Access Compliance Report

Public Rights-of-Way

(Pedestrian Signals)

Intersection ID: N/A	Main Street:	Cross Street: N/A	Location: N/A
ADA ID: EDFF66E83775	Signal Type: Two Push Buttons-APS	Overall Compliance: No	Severity Score: BTN 1:N/A BTN 2: N/A No BTN: N/A
Codes/Mitigation Info/Possible Solution		Field Measurements/Component Compliance

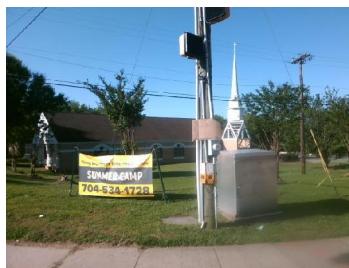
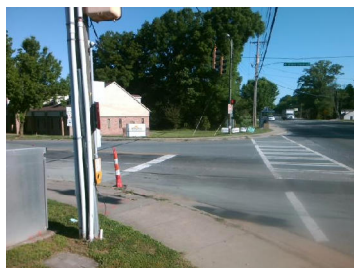
PROW/ADA: R209.1, TMUTCD 4e.08, R404.3, R404.2, R404.7.3, , R404.7.1, R404.7.2

Yes B 1 Clear Xing Direction?	ClearlyMarked	Yes B 2 Clear Xing Direction?	ClearlyMarked
B 1 Crossing Direction	To NE	B 2 Crossing Direction	To NW
Yes B 1 DistanceTo XWalk (in)	41.0	No B 2 DistanceTo XWalk (in)	133.0
No B 1 DistanceTo Curb (in)	83.0	No B 2 DistanceTo Curb (in)	83.0
Yes B 1 Diameter (in)	2.0	Yes B 2 Diameter (in)	2.0

Possible Solutions: Replace Signal Push Button With APS Button on New Post. Remove & Relocate Sign.
